Addendum No. 3

10.05.23

Addendum No. 3: Response to Request for Information in connection with The Invitation to Bid Construction Services: ITB No. 08-79-05624, Historical Museum of South Padre Renovation Project.

PROJECT: Invitation to Bid Construction Services: ITB No. 08-79-05624 Historical Museum of South Padre Renovation Project

2 Proposed Reflected Ceiling Plan
9.1 Scale: 1/8" = 1'-0"

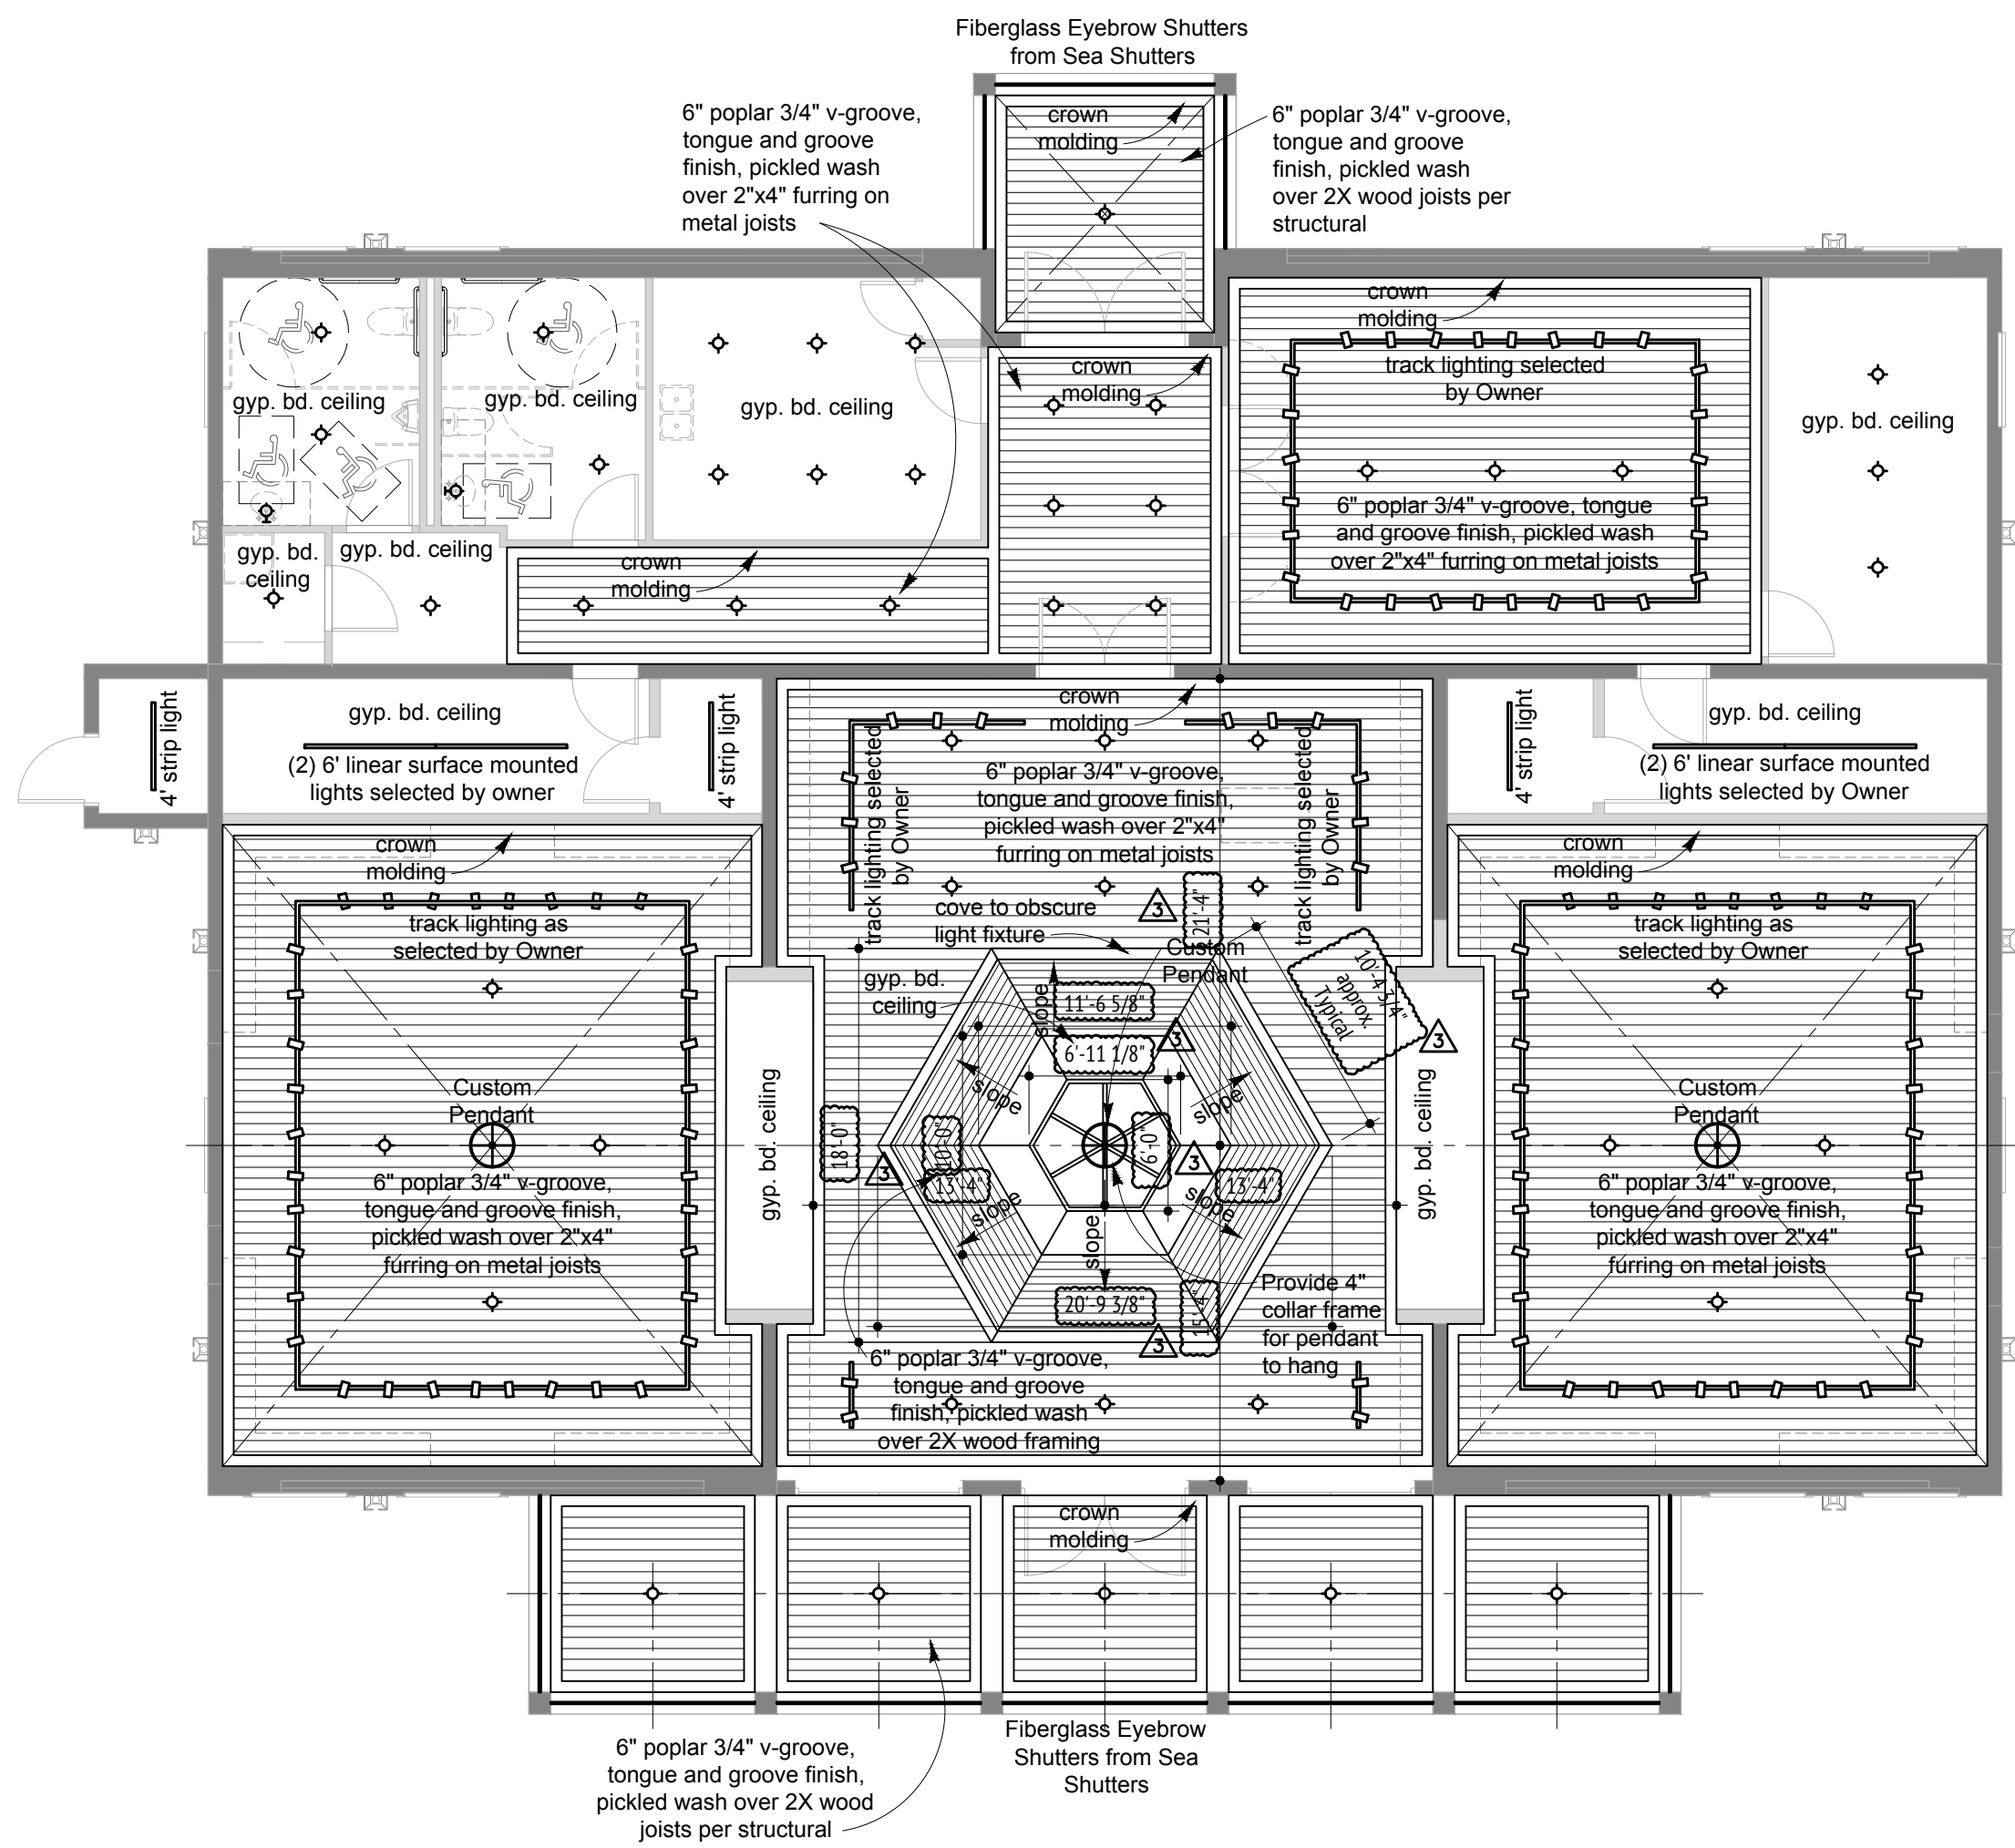
9. The exterior nails are hot-dipped galvanized.
10. The window in the dormer is a Showcase 4'x6' window.
11. Dimensions for hexagon is shown on the ceiling plan, revised sheet 9.1, which is attached hereto.
